Staff Report

Re: PLNSUB2017-00455 and PLNSUB2017-00456 - Tag 500 Townhomes Planned Development and Preliminary Subdivision

Planned Development and Preliminary Subdivision

PROPERTY ADDRESS: 1056 East 500 South
PARCEL ID: 16-05-454-003
MASTER PLAN: Central Community
ZONING DISTRICT: RMF-30 (Low Density Multi-Family Residential)

SD.1

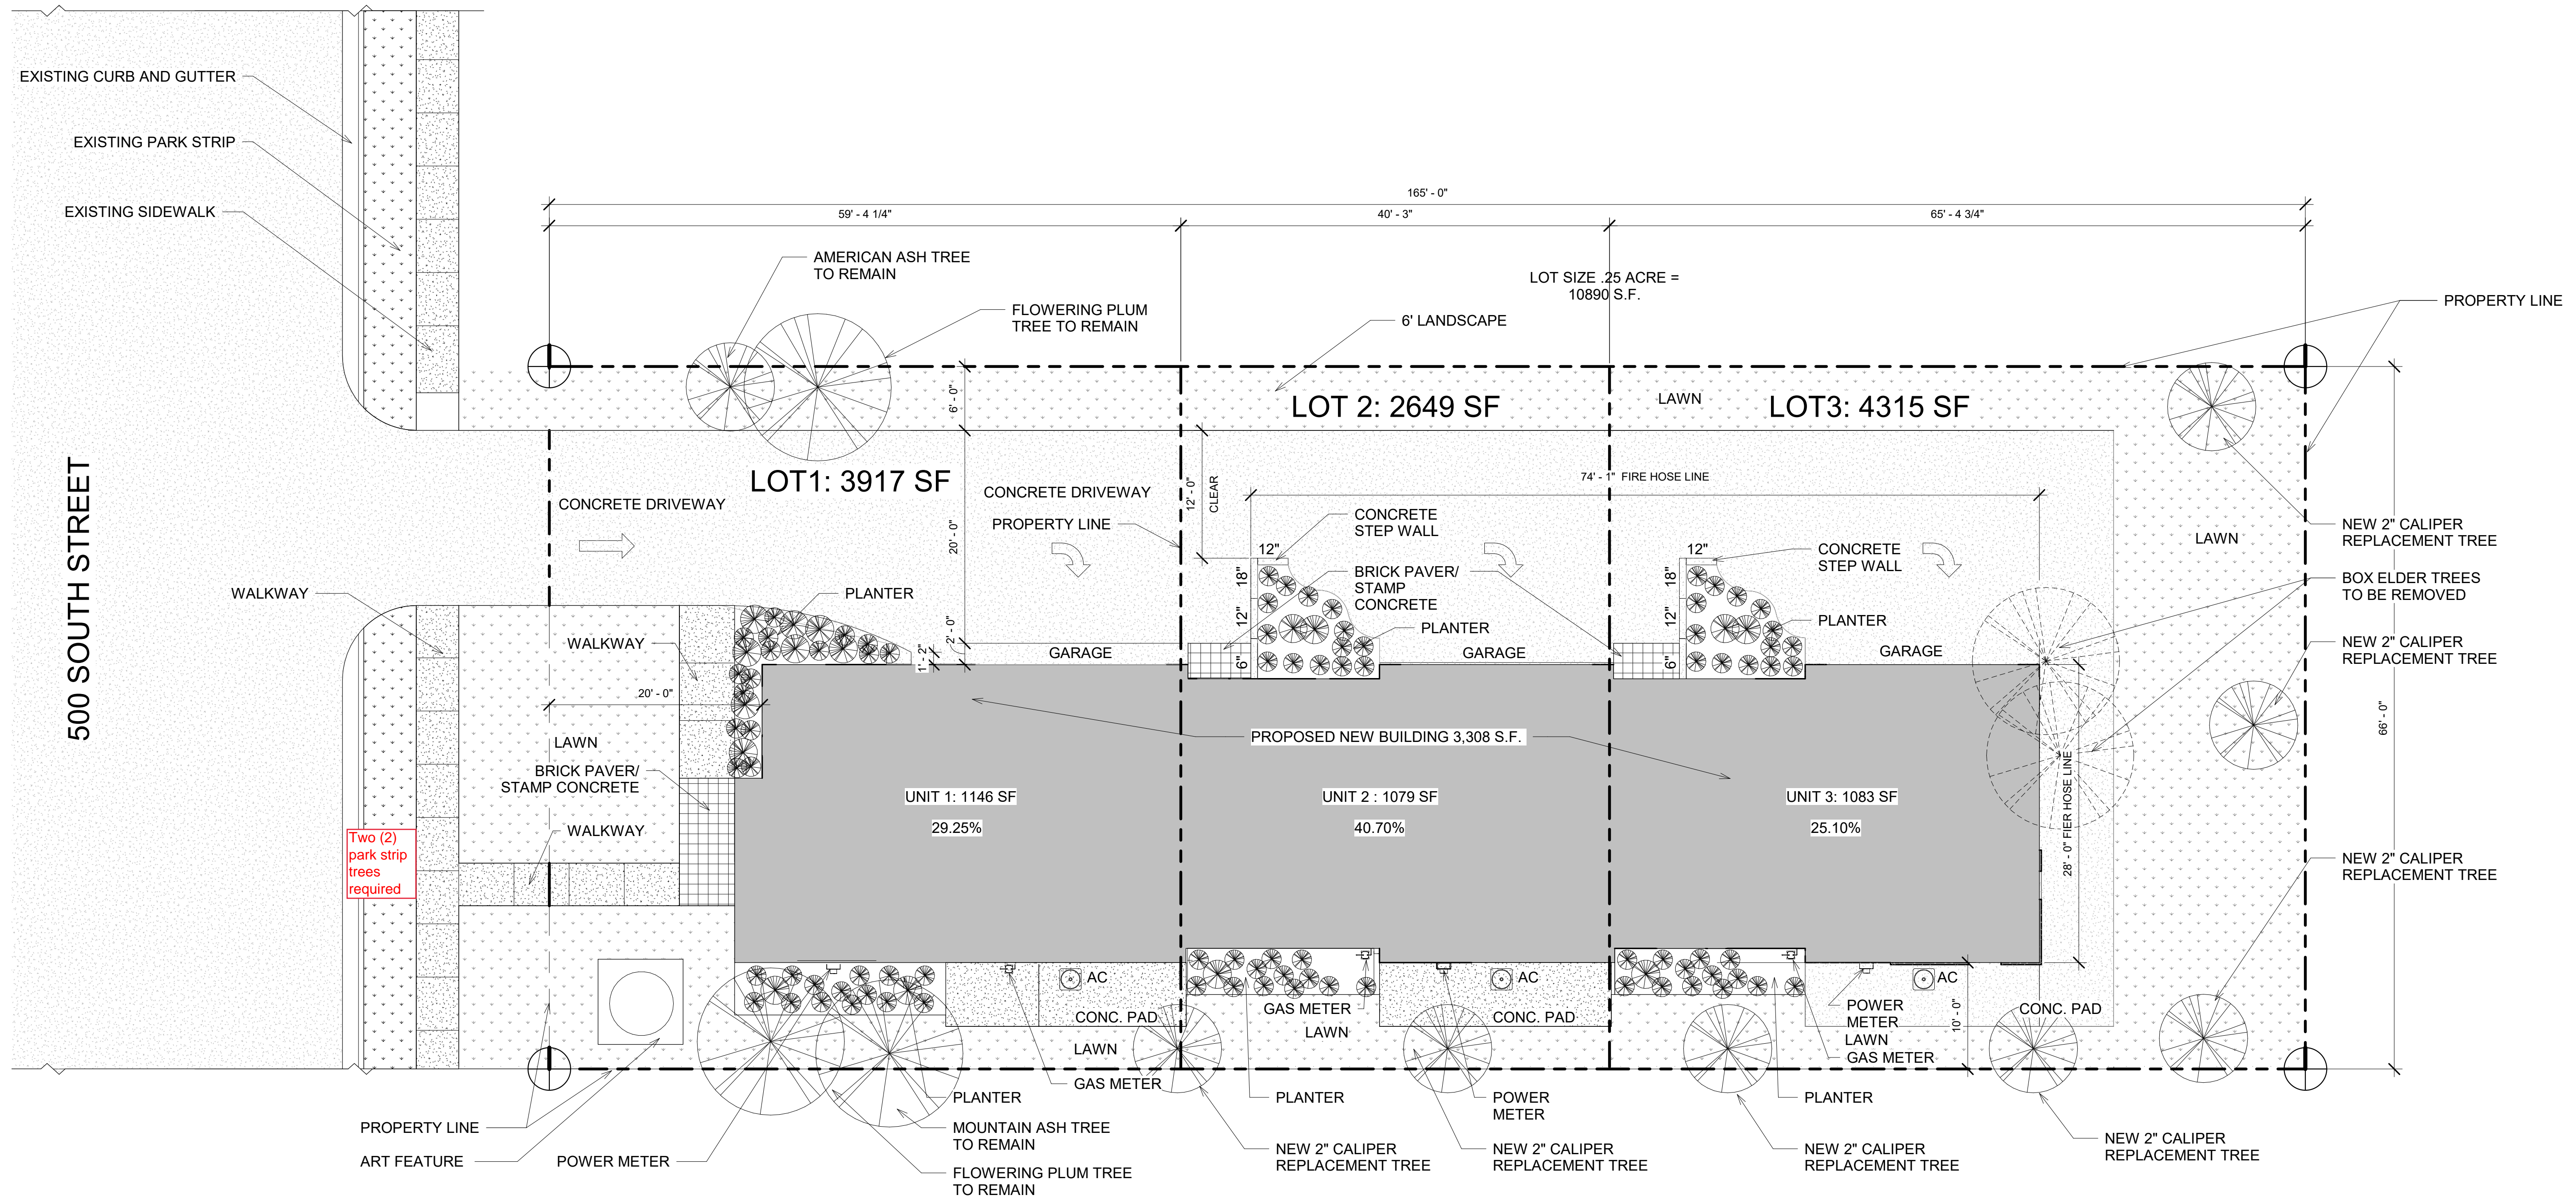
2. Frontage of Lot On Public Street: As proposed, 2 of the lots will not have frontage on a public street.
3. Park Strip Trees: The proposed location of the 2 required park strip trees, and how they relate to all other park strip elements, has not been identified on the Site Development Plan.

5. Front Yard Setback: The location and extent of the front decorative vertical aluminum blinds are not documented on the Site Development Plan to determine whether there is an issue relative to the 20' minimum front yard setback that needs to be addressed.

6. Side Yard Setback: The location and extent of the upper level decks and perforated metal panels around the windows are not documented on the Site Development Plan to determine whether there is an issue relative to the 10' minimum side yard setback that needs to be addressed. It is assumed that the 6' of landscaping on the east side of the driveway, and the landscaping at the east side of each unit is being used to satisfy the 8' of landscaping required for side entry buildings.

7. Rear Yard Setback: The 25' minimum rear yard setback has not been documented on the Site Development Plan.
8. Building Coverage: The building coverage of the entire development has not been documented on the Site Development Plan.

A201

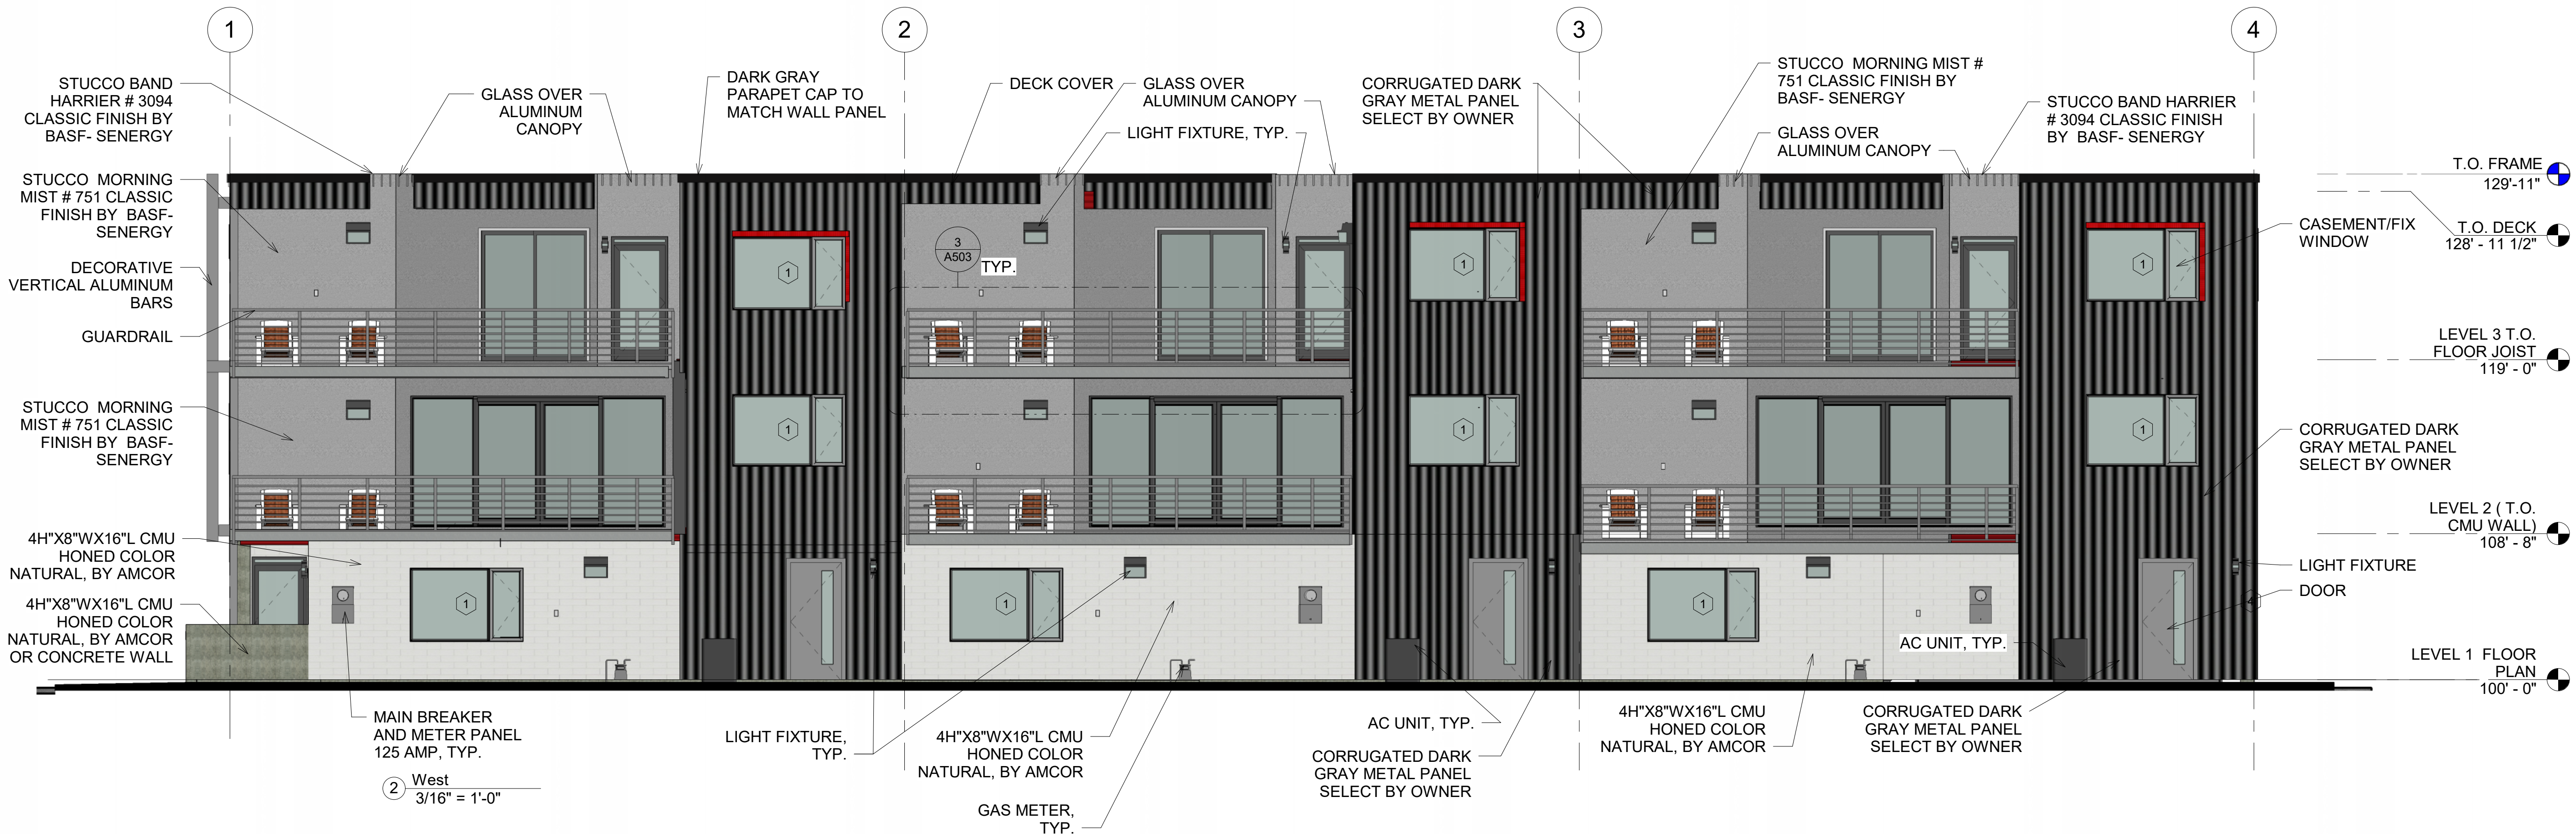
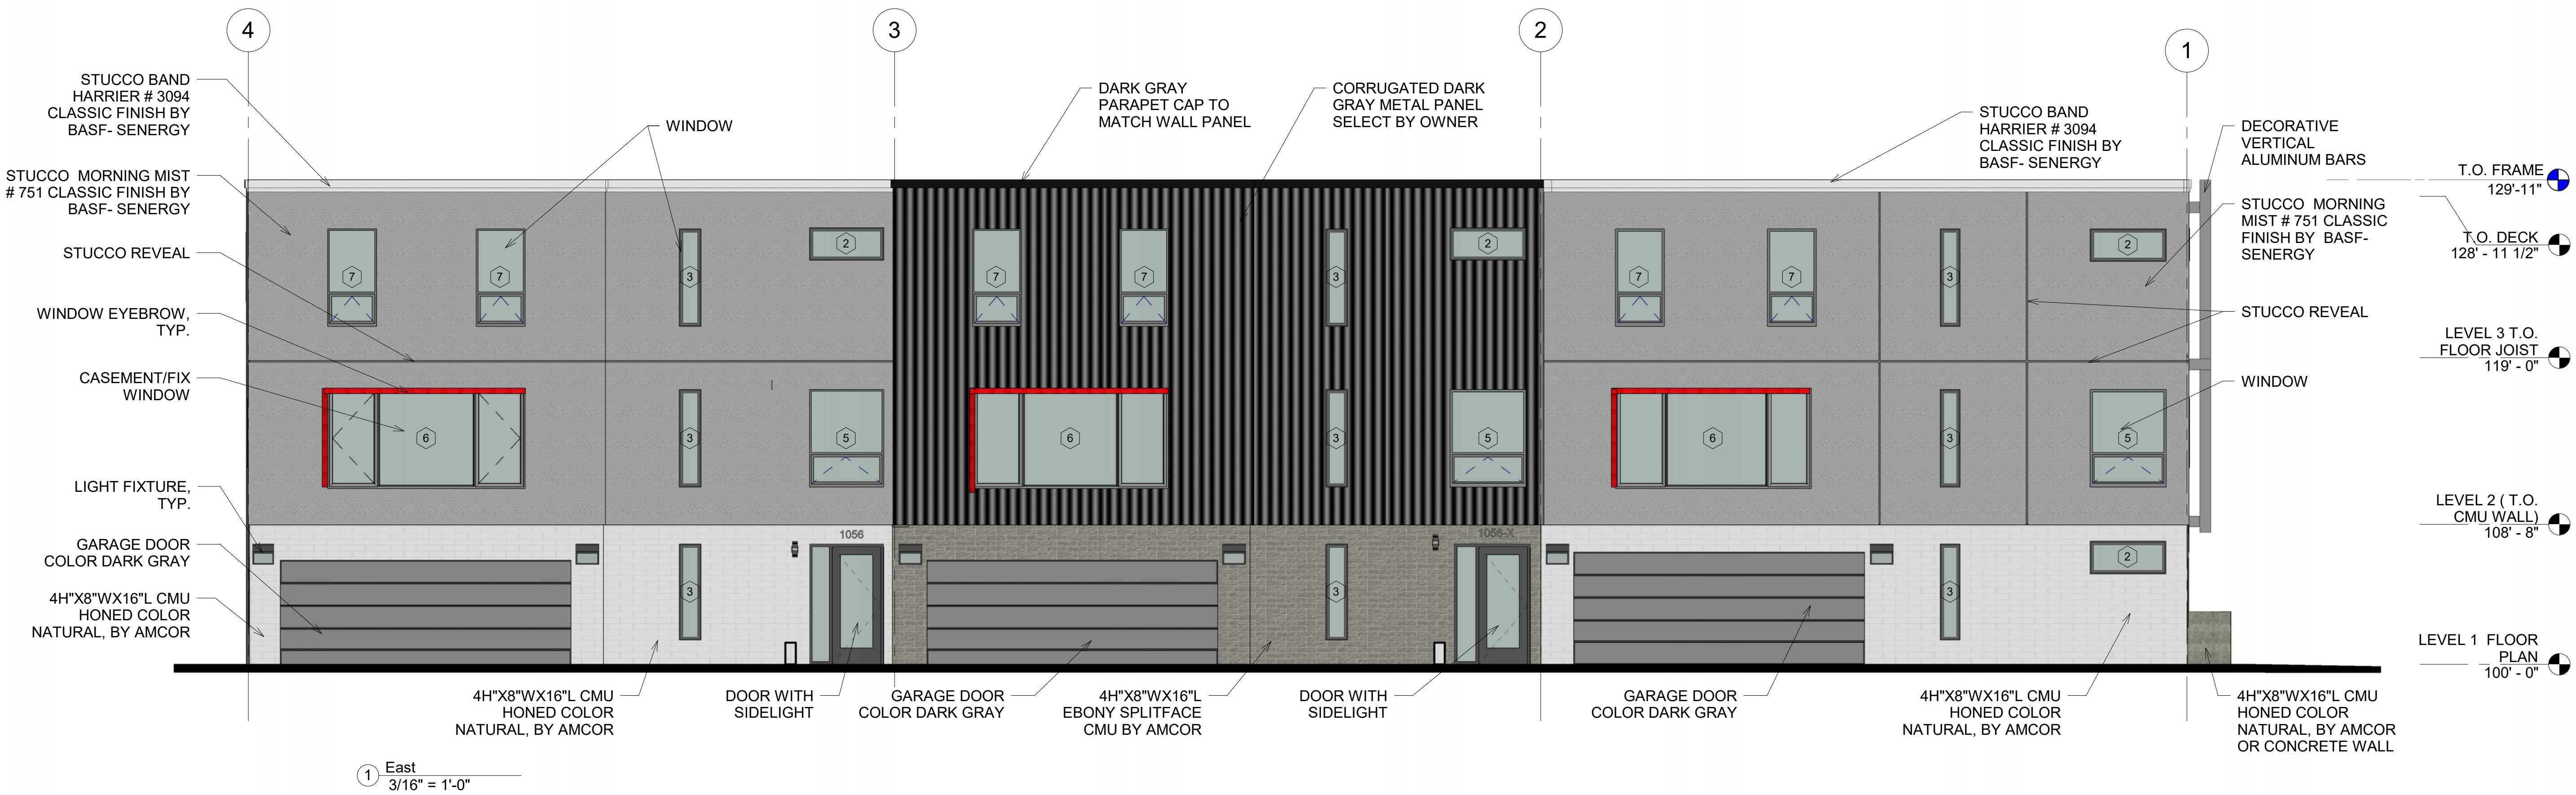
4. Building Height: Building height for this proposal means the vertical distance, measured from the average elevation of the existing lot grade at each face of the building, to the highest point of the coping of a flat roof. To document compliance to this requirement, the existing lot grade elevation needs to be provided at each corner on each face of the building and the average grade for each documented on both the site/grading plan and the elevation drawings. The proposed height of the flat roof, parapet walls, etc., relative to existing lot grade are also to be documented on the elevation drawings.
